ADDENDUM NO. 1

**LA VILLA HIGH SCHOOL NEW AGRICULTURAL
BARN AND LA VILLA HIGH SCHOOL &
ELEMENTARY SCHOOL SITE IMPROVEMENTS
FOR LA VILLA INDEPENDENT SCHOOL DISTRICT
LA VILLA, TEXAS**

DATE: March 14, 2019
PRIOR TO GENERAL CONSTRUCTION PROPOSAL OPENING

ARCHITECT: **RIKE-OGDEN-FIGUEROA-ALEX ARCHITECTS INC.**
1007 Walnut Avenue
McAllen, Texas 78501

1 **ELECTRICAL SITE PLAN**
1"=30'-0"

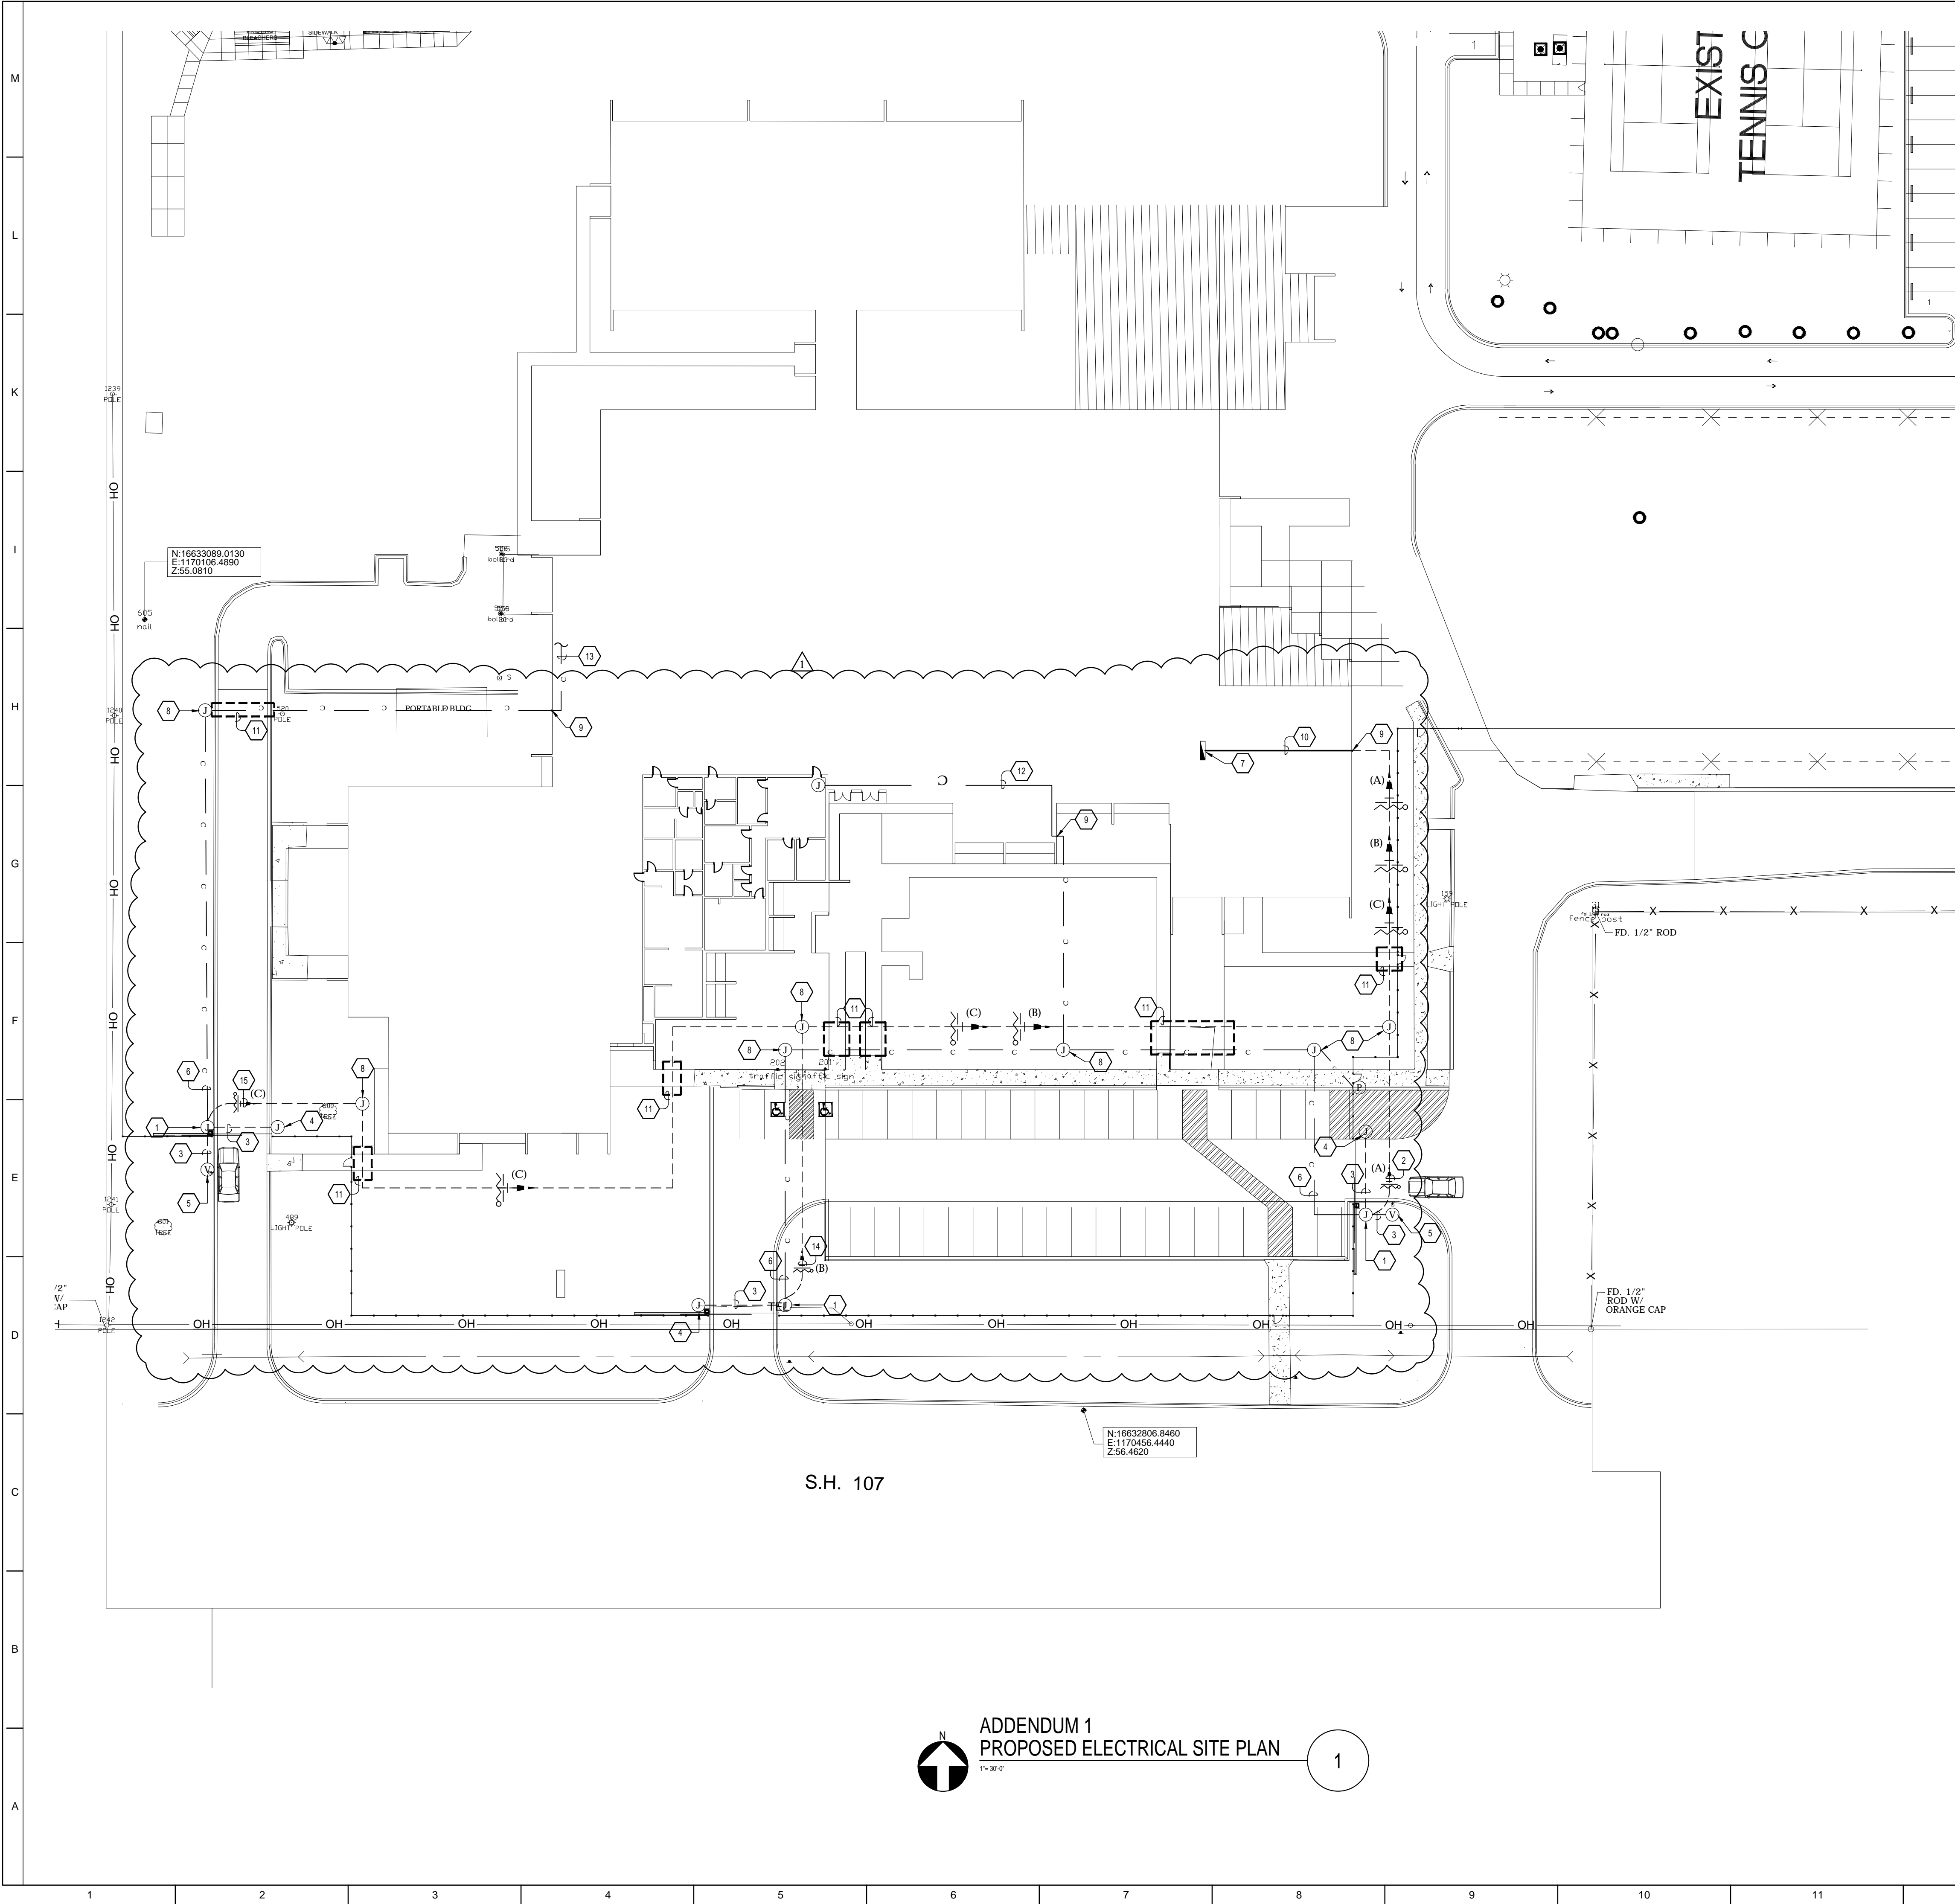
- I. Specifications:
- II. General: N/A
- III. Mechanical: N/A
- IV. Electrical:
 - A. Sheet AES1.1 – Revised electrical service run, refer to attached.
 - B. Sheet AES2.1 – Revised gate power and communication items and keyed notes, refer to attached.
- V. Plumbing: N/A
- VI. Fire Protection: N/A

- 6 CONTRACTOR TO PROVIDE AND INSTALL (1)-4" PVC CONDUIT FROM NEW POWER COMPANY POLE MOUNTED TRANSFORMER TO NEW SERVICE EQUIPMENT. ALL UNDERGROUND WORK SHALL BE ACCORDING TO POWER COMPANY STANDARDS. VERIFY ALL REQUIREMENTS WITH THE POWER COMPANY BEFORE ANY ROUGH-IN. COORDINATE LOCATION, COST, AND INSTALLATION WITH POWER COMPANY PRIOR TO BID.
